HISTORIC AND DESIGN REVIEW COMMISSION

September 16, 2020

HDRC CASE NO: 2020-384
ADDRESS: 503 CEDAR ST
LEGAL DESCRIPTION: NCB 2878 BLK 3 LOT 1&2
ZONING: RM-4, H
CITY COUNCIL DIST.: 1
DISTRICT: King William Historic District
APPLICANT: SAN ANTONIO SAN ANTONIO/MARTIN JAMES HILLERY III
OWNER: SAN ANTONIO SAN ANTONIO/MARTIN JAMES HILLERY III
TYPE OF WORK: Rear privacy fence installation
APPLICATION RECEIVED: August 25, 2020
60-DAY REVIEW: Not applicable due to City Council Emergency Orders
CASE MANAGER: Rachel Rettaliata

REQUEST:

503 Cedar Street

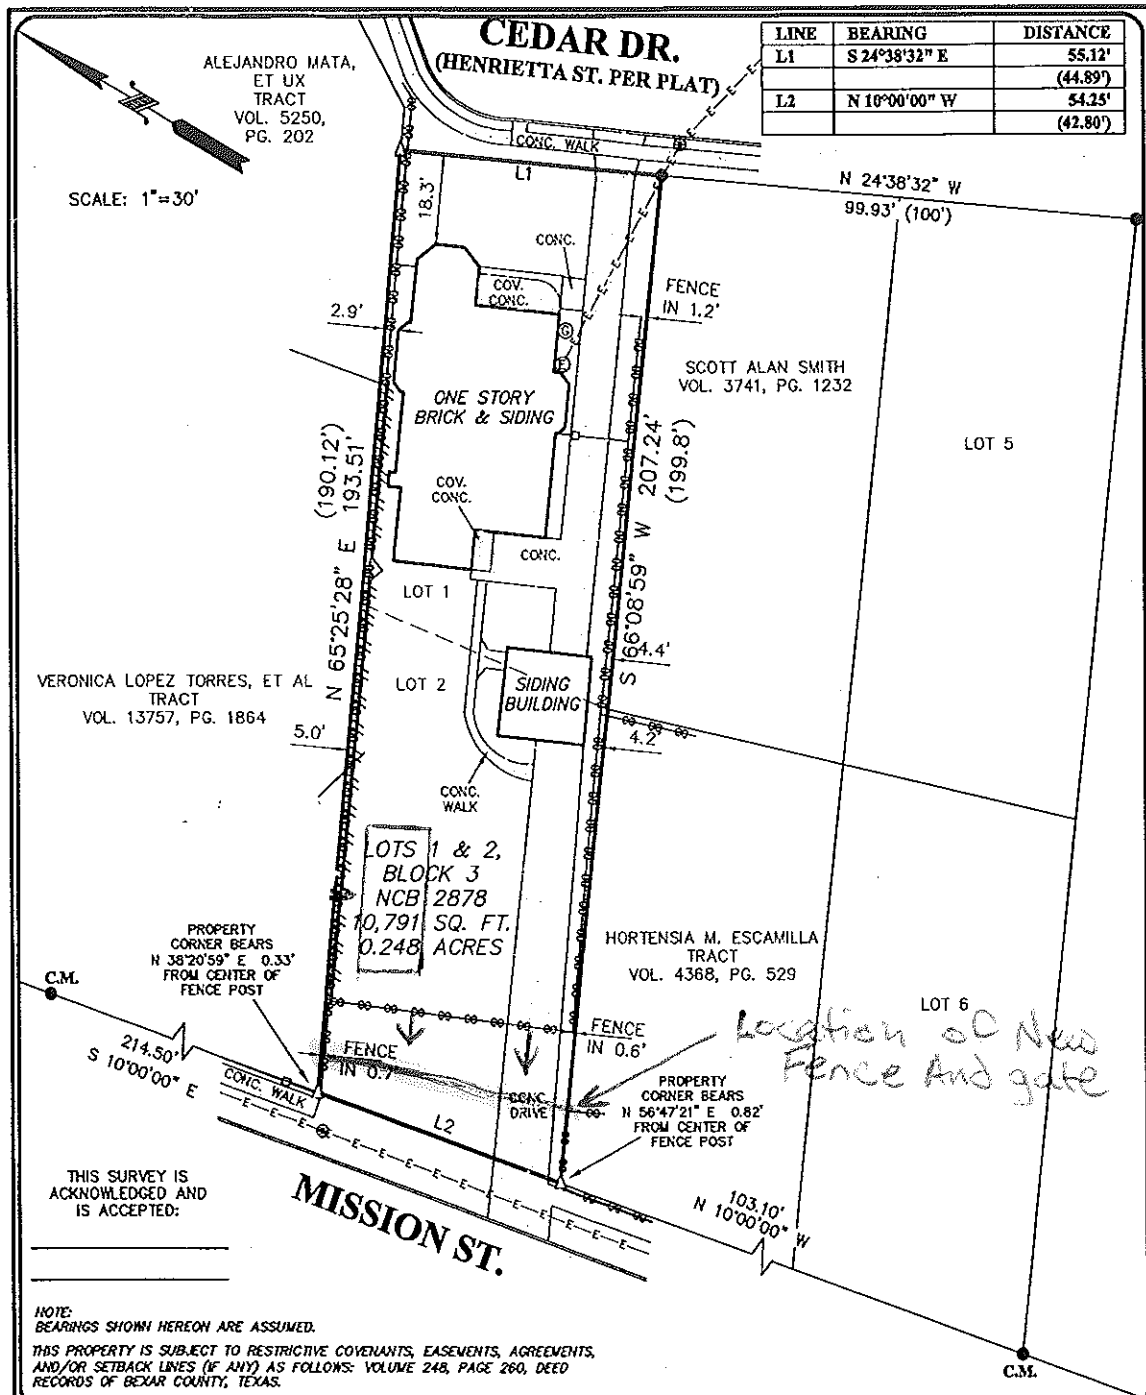
- c. FENCE LOCATION – The applicant has proposed to install a 6-foot-high wood rear privacy fence at the rear of the property to be in line with the existing front yard fences on Mission Street. An existing chain link fence and driveway gate is currently located at the rear of the property. The existing rear fence and gate is set back from the rear property line along Mission Street. The property features a unique site condition as it fronts Cedar Street and the rear of the property faces Mission Street. All other properties located on Mission Street feature structures that front Mission Street. Guideline 2.C.i for Site Elements states that privacy fences should be set back from the front façade of the building, rather than aligning them with the front façade of the structure to reduce visual prominence. According to Guideline 2.C.ii for Site Elements, do not use privacy fences in front yards. Although the applicant is proposing to install a privacy fence in the rear yard of the property, the rear yard at 503 Cedar reads as a front yard and the installation of a 6-foot-high rear privacy fence in line with the existing front yard fences on Mission Street is inconsistent with the Guidelines. Staff finds the proposal inappropriate.

Staff does not recommend approval of the fence installation based on findings a through c. Staff recommends that the applicant install a 6-foot-tall wooden privacy fence in the same location as the existing rear fence.
